**INVITATION TO BID
ADDENDUM NO. 2**

ITB NO.: 34900

DESCRIPTION: Meacham Maintenance Station

THE PURPOSE OF THIS ADDENDUM IS TO:

ROOF DETAILS

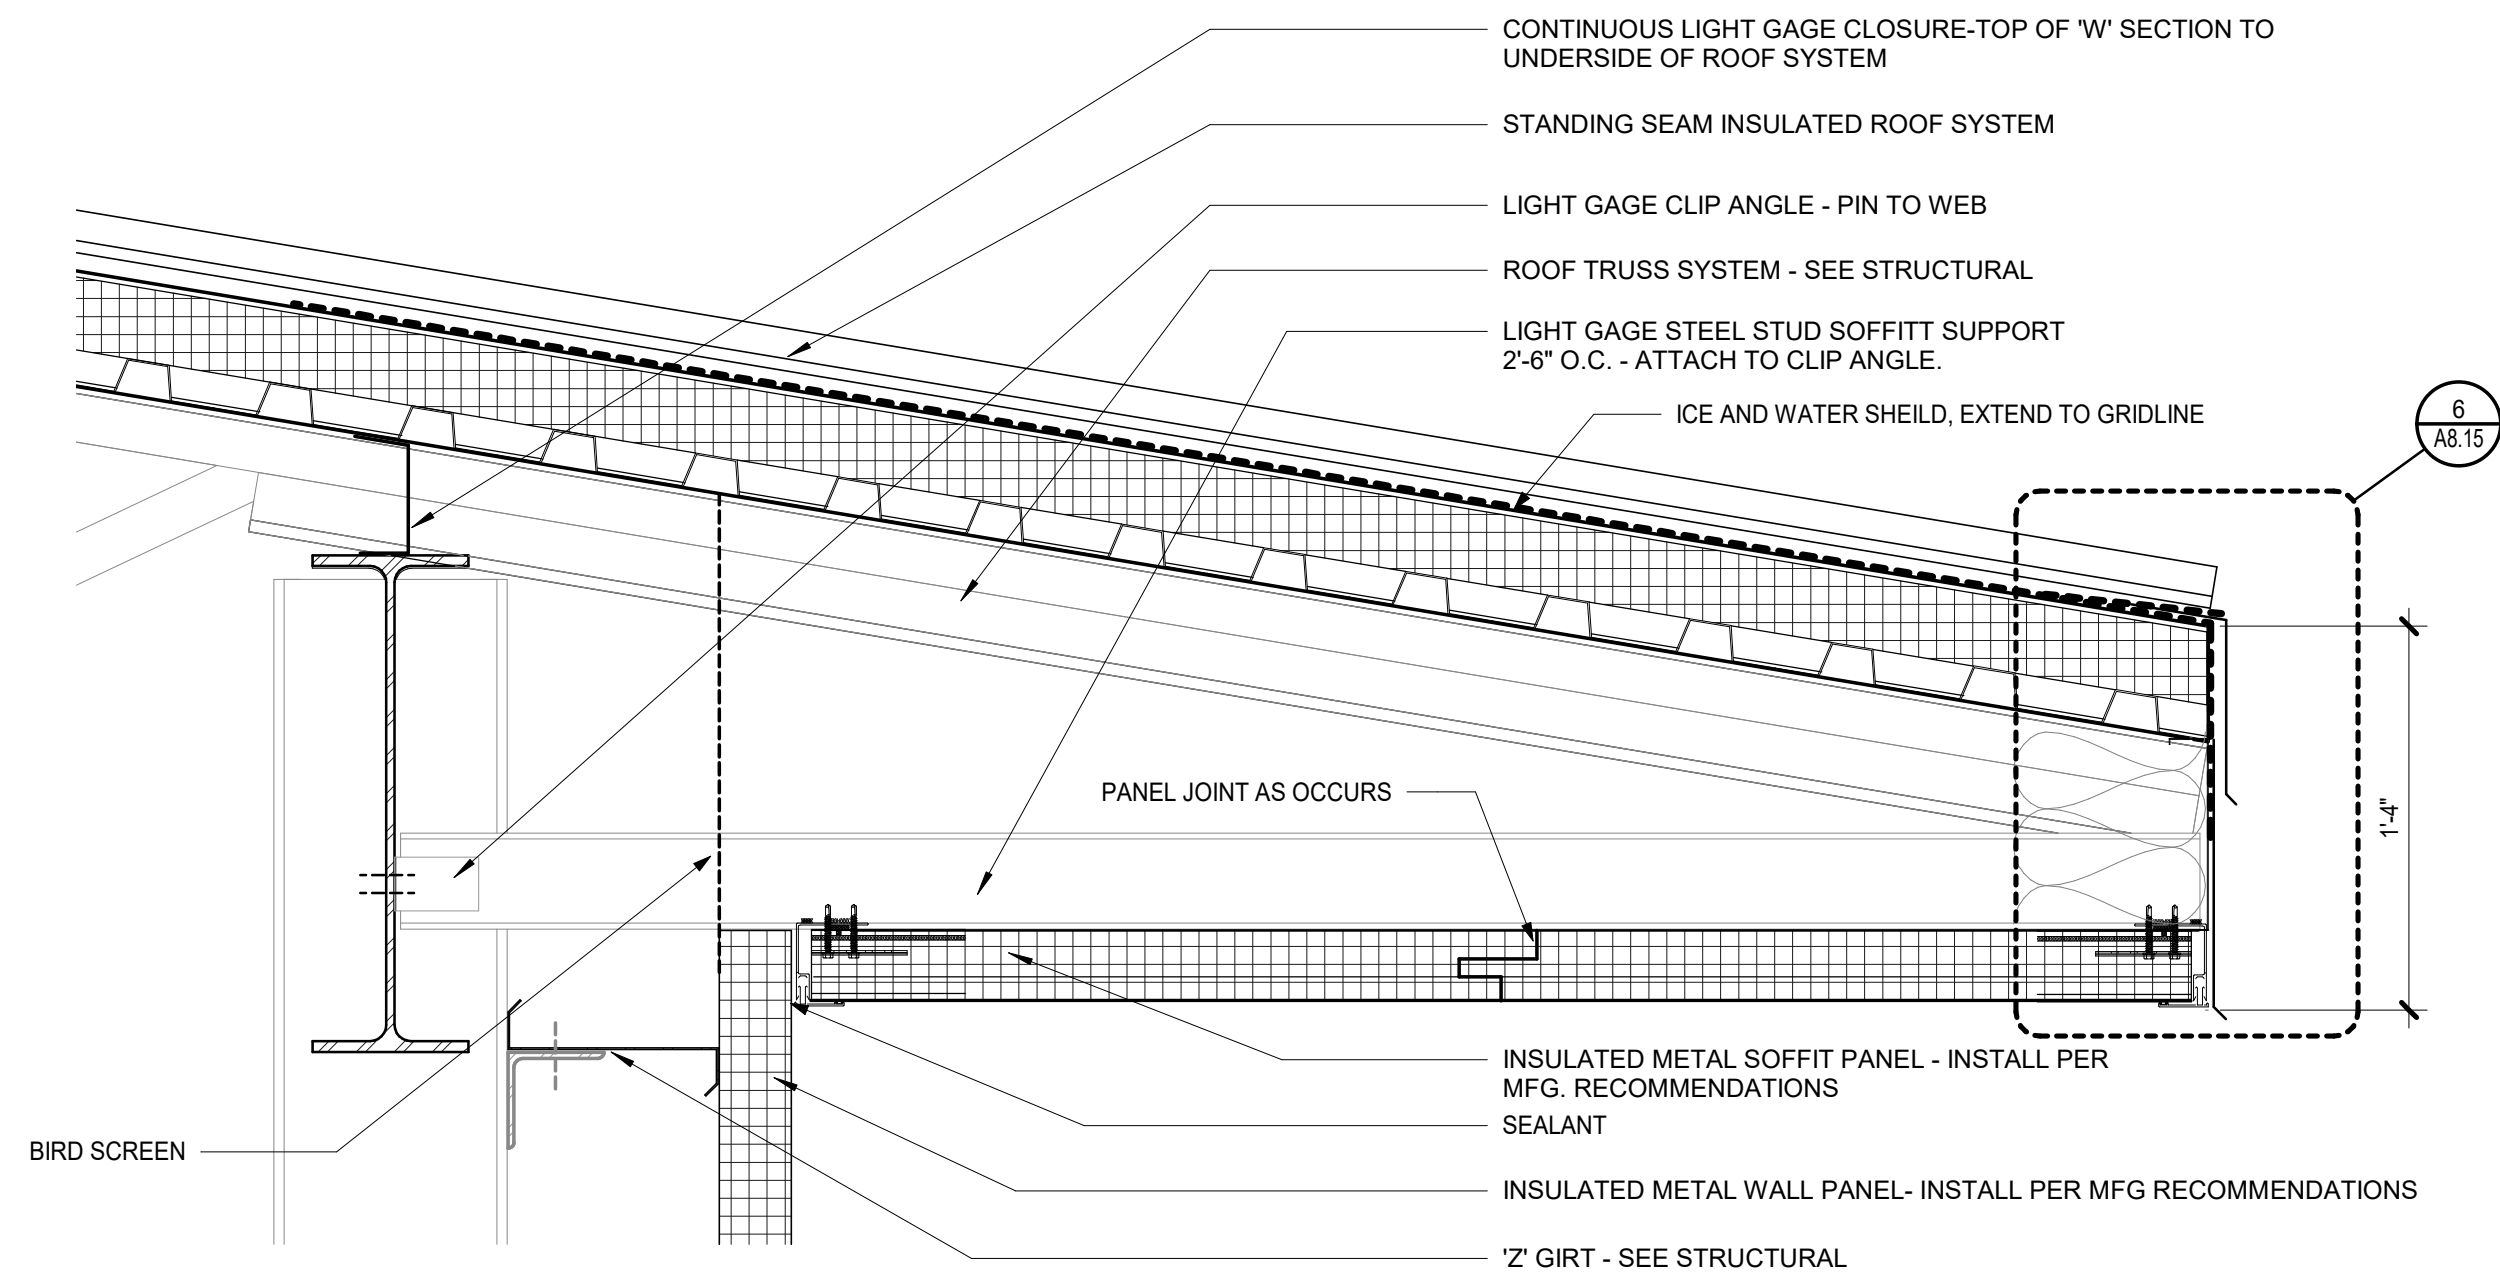
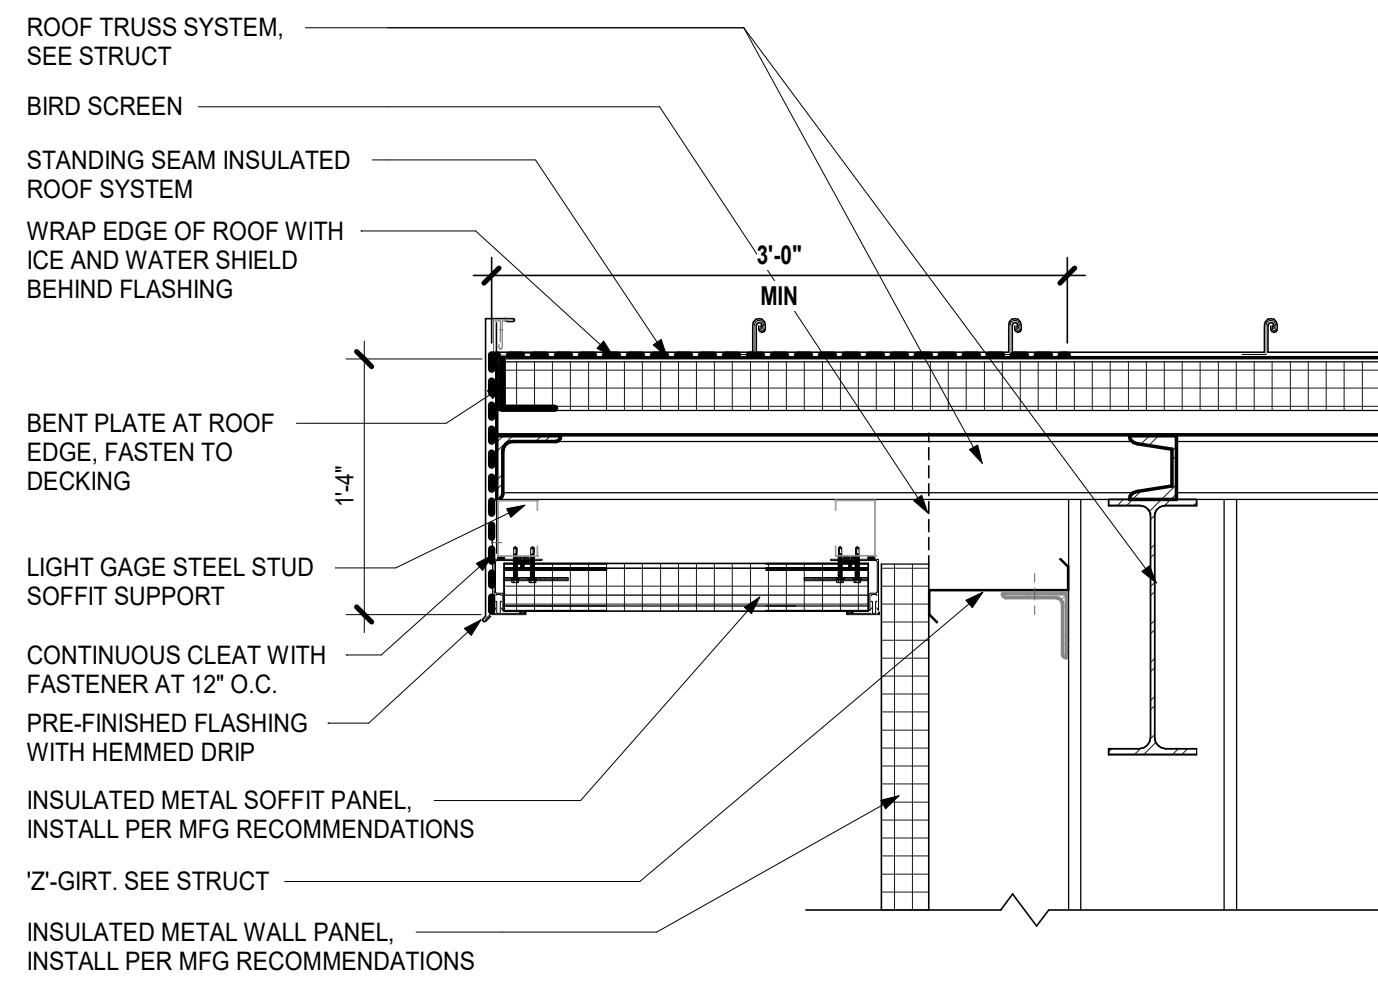
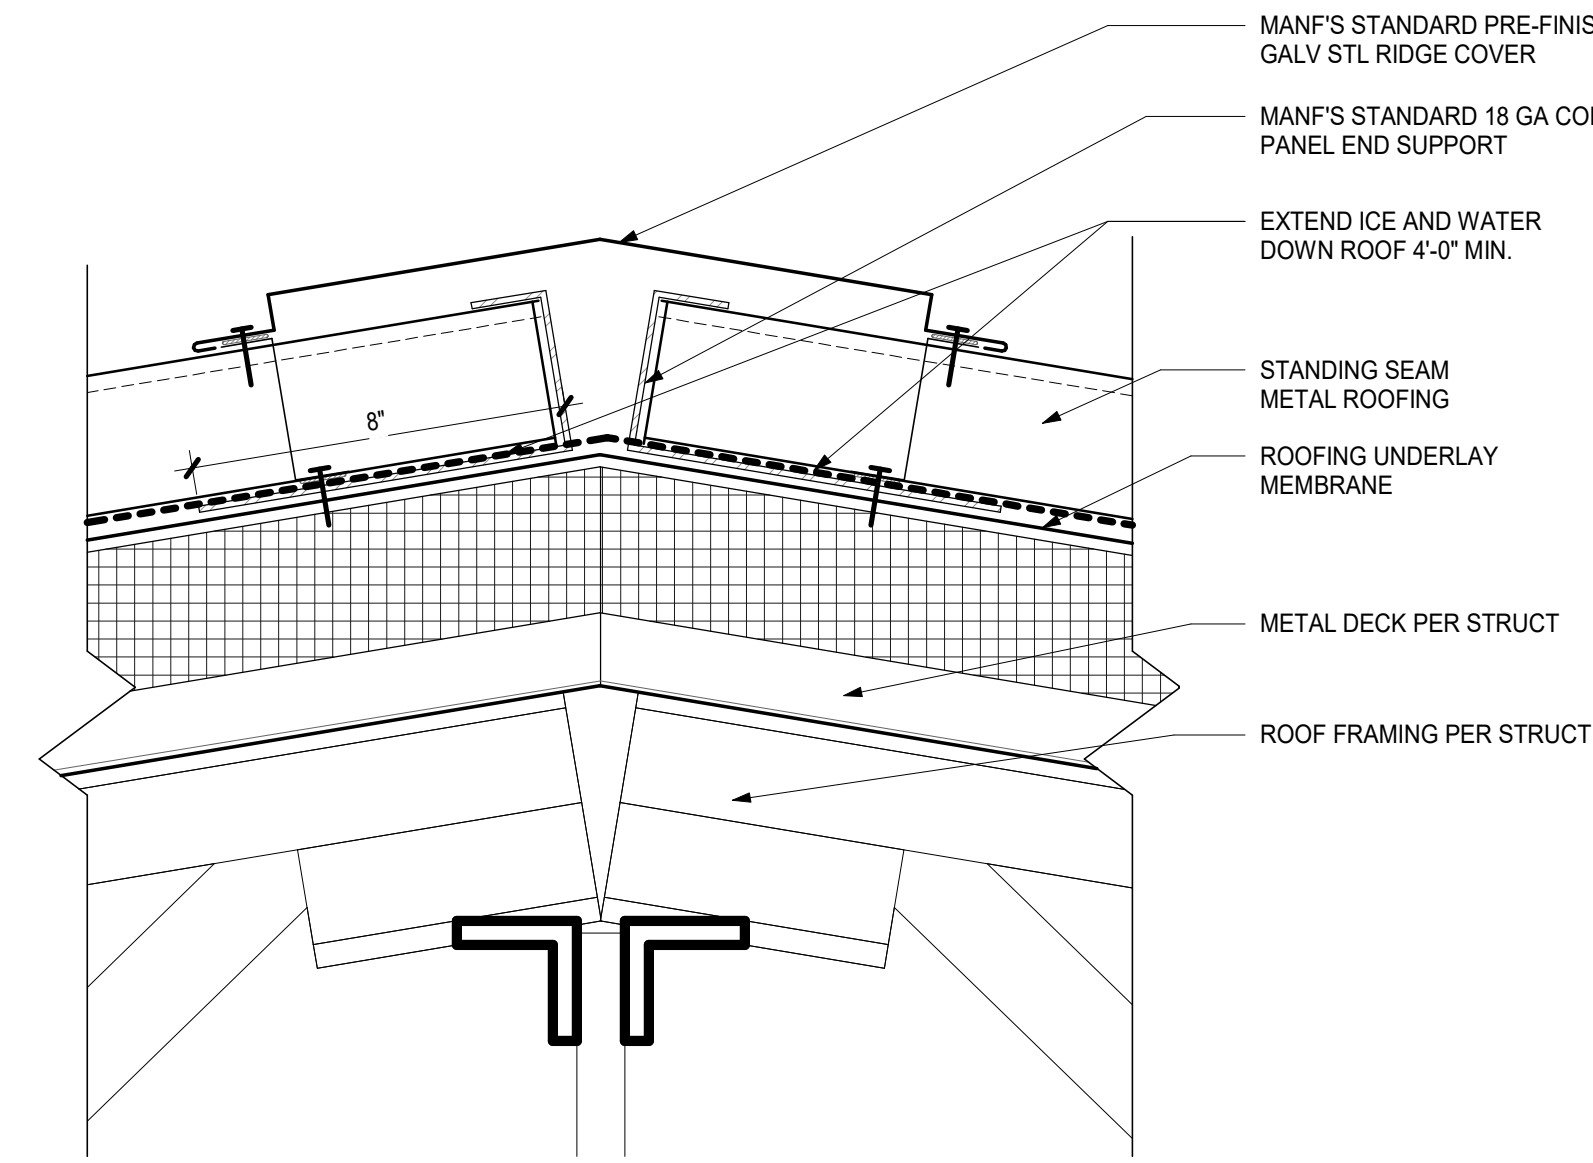
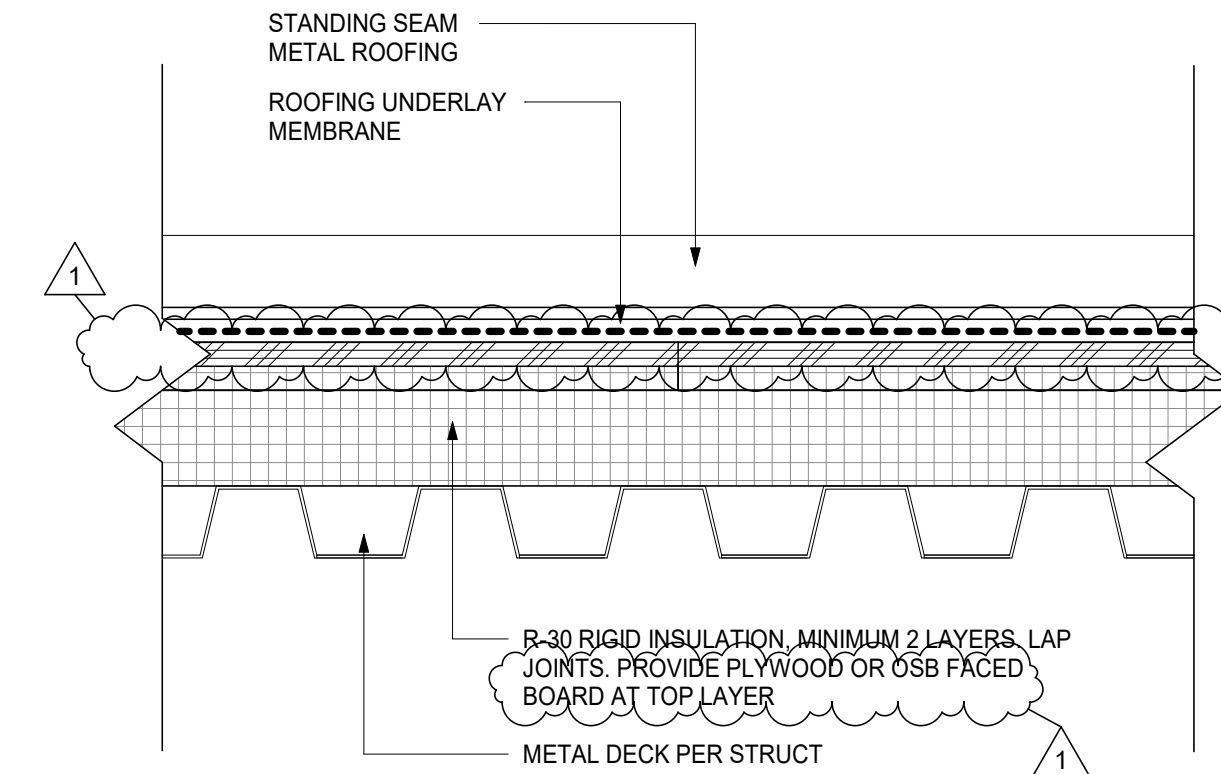
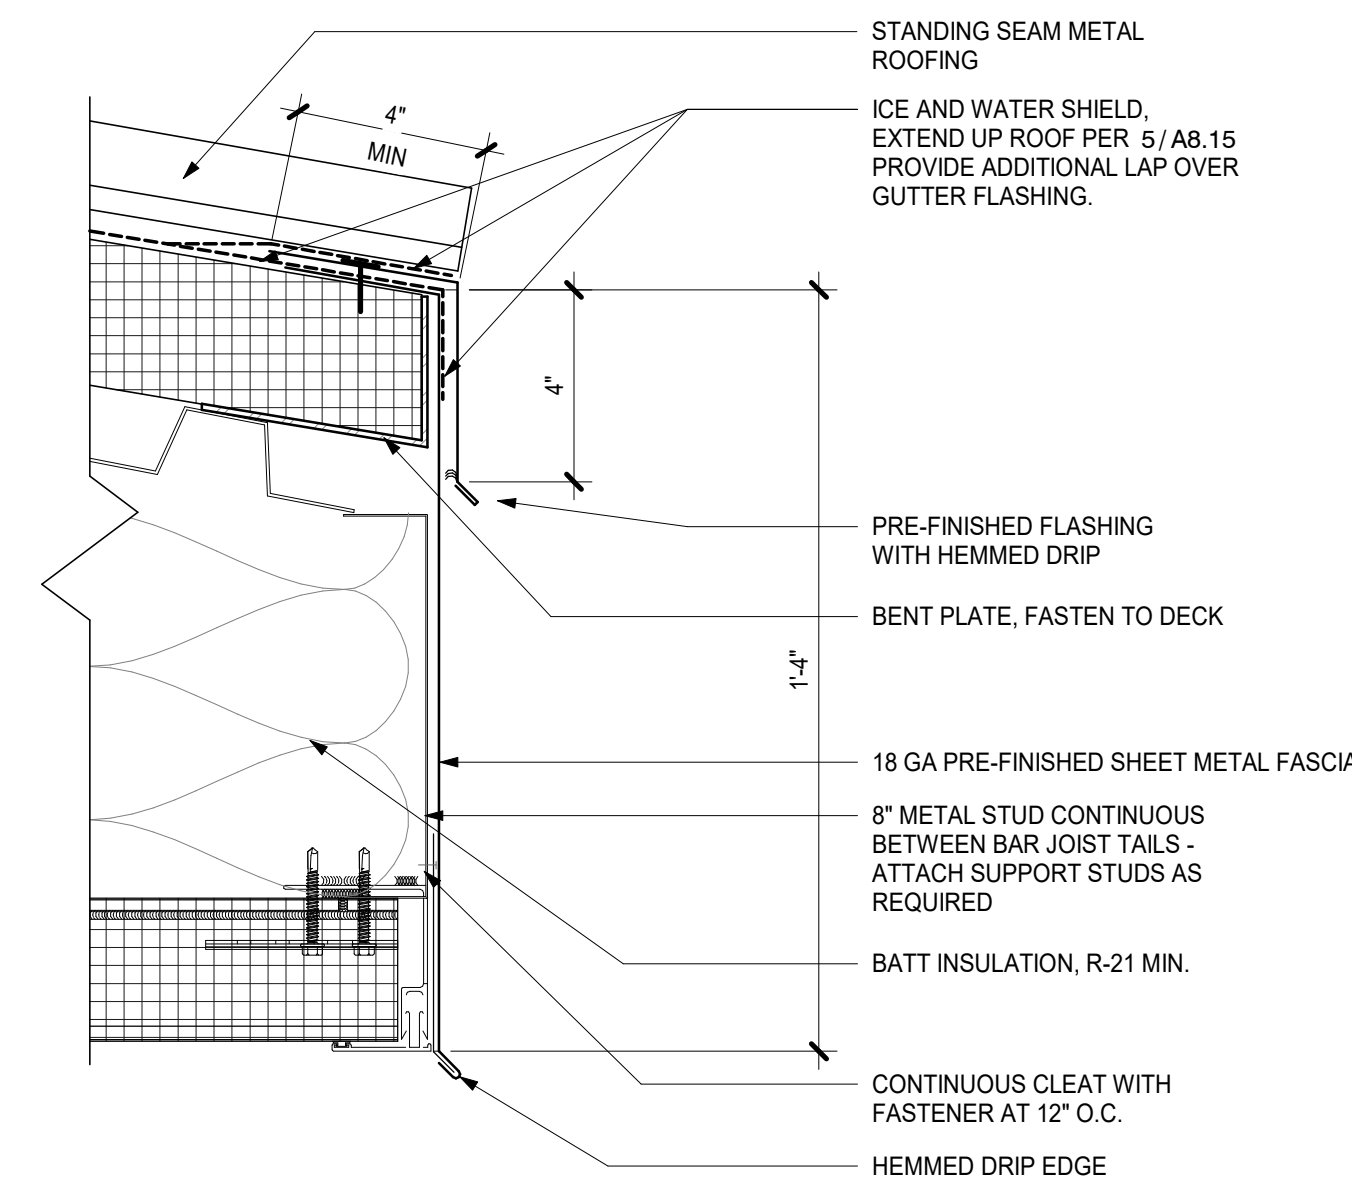
- Replace Exhibit 1 in it's entirety with "Exhibit 1_Addendum 2" attachment that adds a line item for anticipated rock removal (RFI #7)
- Add Attachment "July 1, 2021 RFI and Approval List"
- RFI #28 – Add Revised Specification and Drawing – See attached "Add 2 07 2100 & Add 2 A8-15 Roof Details
- RFI #88 – Motion Sensor required for pendent lights - **ITEM I - Drawings**
 - **Sheet G-E0.0 - Electrical Cover Sheet**
 - 1. Revise Type 'G' Lighting Fixture Description to read:
 - PENDANT MOUNTED HIGH BAY DOWN LIGHT (1) 146 WATT LED. 15.25" X 44" SIZE. 18,000
 - LUMENS. SOLID TOP. SEMI-DIFFUSE ACRYLIC LENS. NARROW DISTRIBUTION. 120V. 0-10V
 - DRIVER. 4000K. 80 CRI. 360° MOTION SENSOR. LITHONIA: IBHST-18000LM-SD080-ND-120-
 - OZ10-40K-80CRI-LAOZU OR APPROVED.

No.	Sub Name	Description	By	Date	Status	Cost Y/N	Comments	Comments2
27	Griffin	Architect to Confirm Roof Insulation	CE	6/23/2021	Closed	N	R-30 insulation is required to meet energy code requirements for the building. Detail is for schematic purposes, and it not intended to illustrate final roof thickness. Provide minimum 2 layers of insulation to achieve required R-value.	Soderstrom Response
28	Griffin	Is plywood nailer required?	CE	6/23/2021	Closed	N	See Revised detail 4/A8.15 and revised Specification 07 2100 for plywood or OSB faced polyiso for use as top layer at roof assembly.	Soderstrom Response Revised 07-2100 Spec and Revised A8-15 Roof Drawing
29	Griffin	Does PEMP Supplier provide siding, flashings, and roof?	CE	6/23/2021	Closed	N	ODOT expects the PEMB Supplier to provide siding, flashings, and roof as part of their complete package. However, if General Contractor wants to supply parts of building, they will be responsible for coordination of details and meeting specifications and providing proper fit up.	Crow Response
